RE: Response to Colorado Geological Survey Comments, 5050 Neeper Valley Road, Geoquest #17-1043

Reference: Geologic Hazard Report, Geoquest #17-1043, 21 June 2021
 Comments from Colorado Geological Survey, 10 September 2021

Attachment: Revised Slope Stability Analysis

Analysis 1 (stage 6)

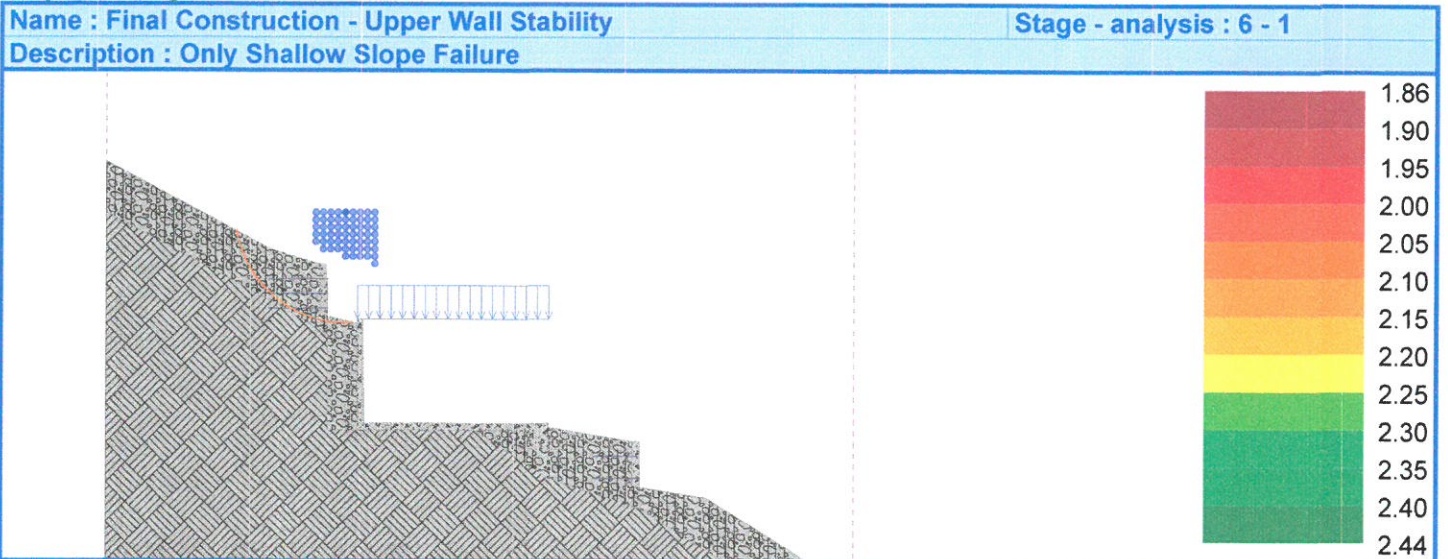
Regarding the final slope stability, CGS indicated the upper wall stability was inadequate. This is correct, based on the given topography and proposed wall heights, the slope stability is inadequate at the upper wall. This can easily be corrected by extending the top of wall up two feet and properly reinforcing or including shear keys. This wall should be designed by a licensed Colorado Professional Engineer, either a MSE wall or reinforced concrete is recommended. The wall design should include analysis of slope stability. We believe a properly designed wall will be able to achieve a slope stability of greater than 1.50.

Factor of safety = 1.86 > 1.50

Name : Final Construction - Downslope Stability

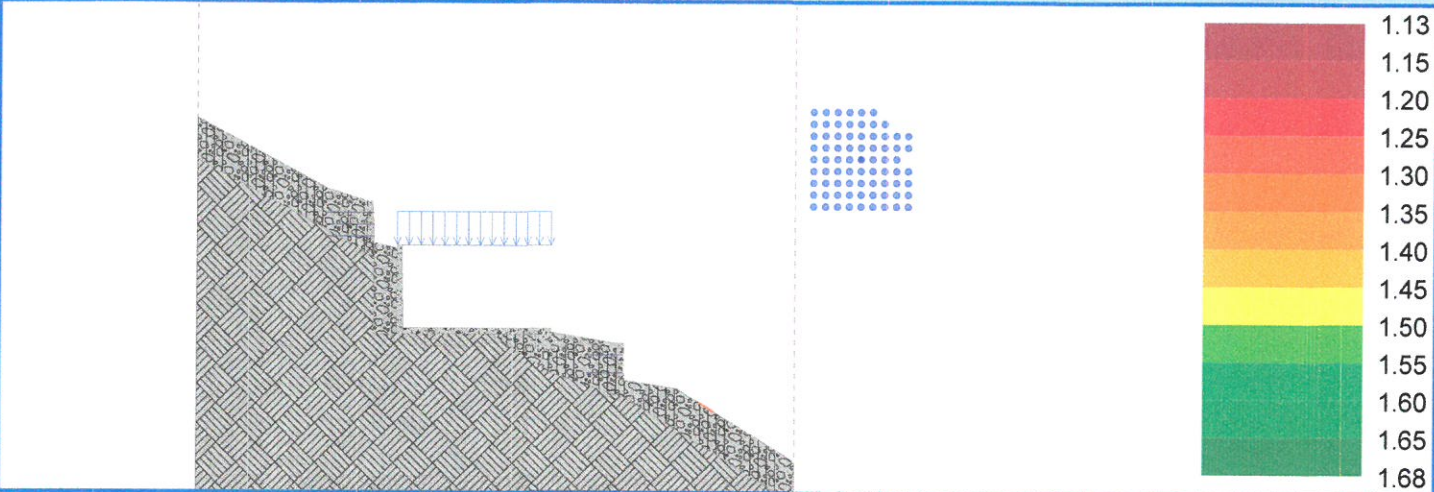
The native downslope stability has a factor of safety of 1.13 which matches the preconstruction stability downslope of the proposed structure. The proposed construction has no impact on the native slope stability past the area of disturbance. Therefore, we believe no additional constraints should be placed upon stabilizing the native slopes.
